Access Compliance Report

Public Rights-of-Way

Intersection ID: 11933	Main Street: E_8TH_ST	Cross Street: N_TRYON_ST	Location: E
ADA ID: 08109D4EB356	Ramp Type: Directional1	Initial Pass/Fail: Fail	Overall Compliance: No
Severity Score: 12.5			
Codes/Mitigation Info/Possible Solution		Field Measurements/Component Compliance

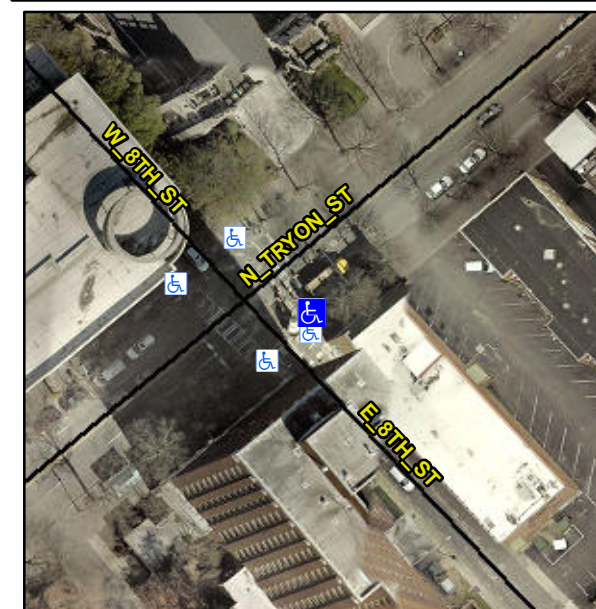
R304.2.2

Compliance	Description	Data	Compliance	Description	Data
N/A	Ramp Length (in)	64.0	N/A	Grade Break?	N/A
Yes	Ramp Width (in)	51.0	N/A	Grade Break Slope (%)	0.0
No	Ramp Slope (%)	9.2	N/A	Grade Break XSlope (%)	0.0
Yes	Ramp XSlope (%)	1.3			
N/A	Flare Type LT	N/A	N/A	Flare Type RT	N/A
N/A	Flare Slope LT (%)	N/A	N/A	Flare Slope RT (%)	0.0
N/A	Flare Traversable LT?	N/A	N/A	Flare Traversable RT?	N/A
N/A	Landing Length (in)	0.0	N/A	DWS Provided?	N/A
N/A	Landing Width (in)	0.0	N/A	DWS Contrast?	N/A
N/A	Landing Slope (%)	0.0	N/A	DWS Length (in)	N/A
N/A	Landing X Slope (%)	0.0	N/A	DWS Full Width?	N/A
N/A	Landing Curb? (Y/N)	N/A	N/A	DWS Offset LT (in)	N/A
N/A	Shared Landing?	N/A	N/A	DWS Offset RT (in)	N/A
N/A	Gutter Ponding?	0.0	N/A	Gutter Slope (%)	N/A
N/A	Gutter Lip Ht (in)	0.0	N/A	Gutter X Slope (%)	N/A
N/A	Painted X Walk1?	Yes		Road Slope (%)	5.2
	X Walk 1 Direction	To NW		Road X Slope (%)	4.7
	X Walk 1 Width (in)	124.0		Clear Space?	N/A

Remove & Replace Entire Ramp.
